July 14, 1999

This letter is to request a review of several changes planed to the Metorex SIPS probe which is currently covered by Registry NR-0701-D-104-B. These modifications are in the latter stages of design and evaluation but have not yet been formalized. These changes will be implemented in the fall of 1999 and will occur in all probes. Thus, these modified probes will be identified by a serial number greater than a certain number that will be determined at a later date.

## **Modifications to SIPS Probe NR-0701-D-104-B**

FIGURE 10. LOCATION OF DOSE RATE MEASUREMENT POINTS

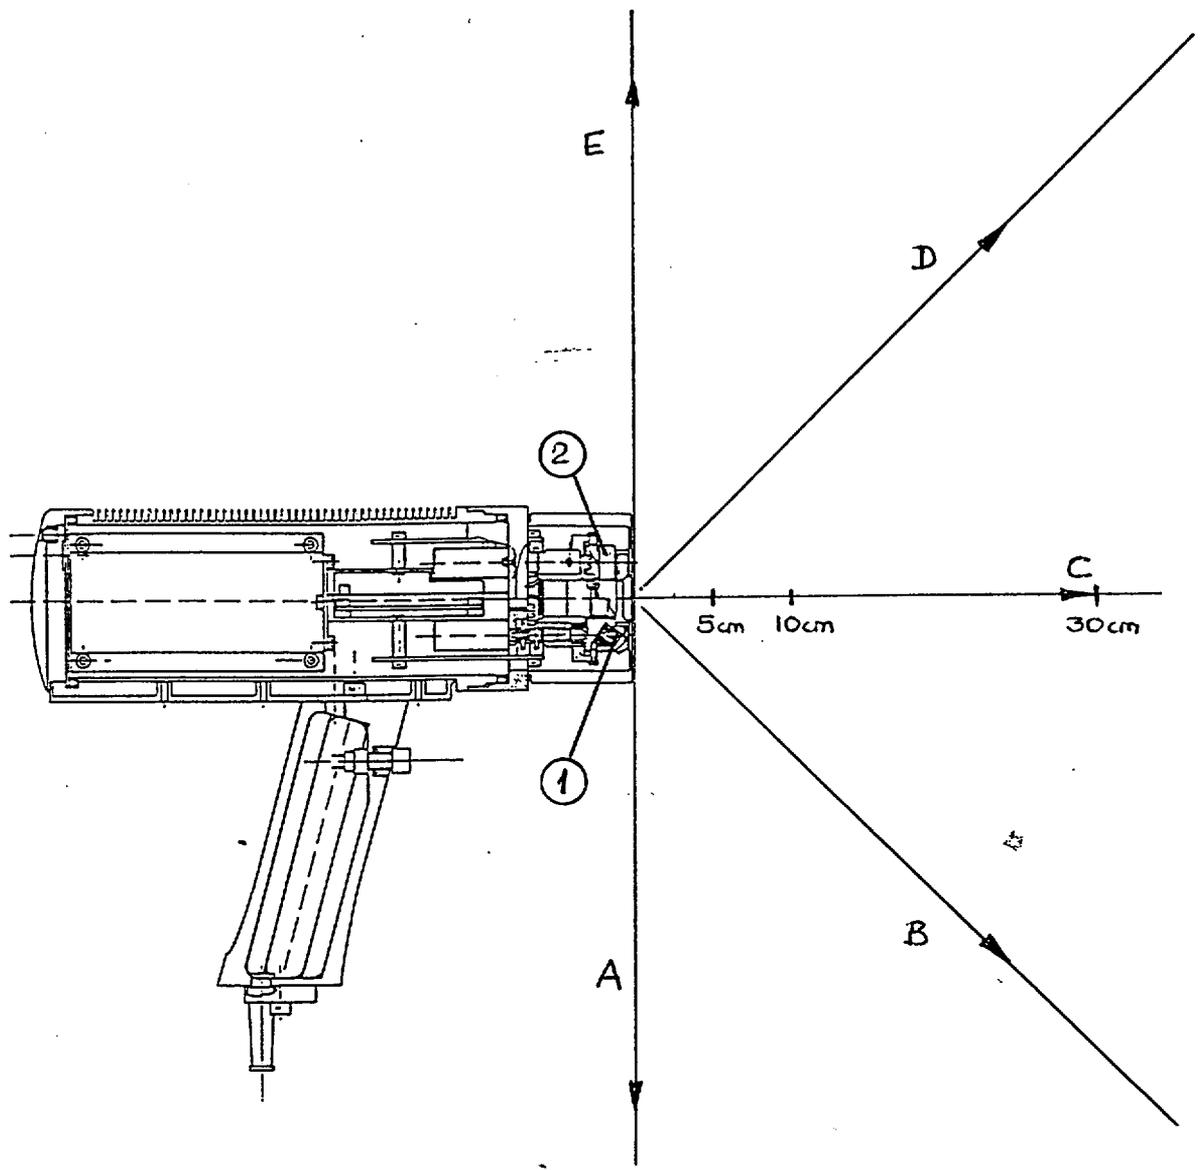
In order to determine the effect of these changes on the radiation profile, measurements were made using the same Cd-109 source in both the current designed probe and the revised probe. Cd-109 was chosen as it has the highest radiation profile in the testing of the original probe. The measurements were made using a Giger counter to monitor the primary beam. A scintillation detector was used to measure the weak radiation in other directions. The following comparative table shows the radiation along the axis illustrated in figure 10 (p9):

These profiles indicate that there is essentially no difference in the radiation profiles of the two designs.
